■ Specification and Appearance Differences Due to Specification Changes

■ Part numbers subject to specification changes

Type : CFFR/CFR

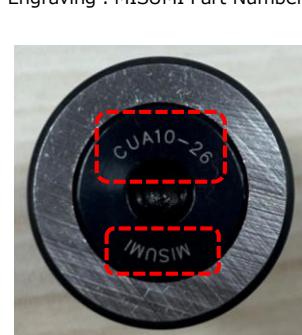
[Before Change]

Engraving : Manufacturer Part Number, Manufacturer Logo, Country of Origin

[After Change]

Engraving : MISUMI Part Number, MISUMI Logo
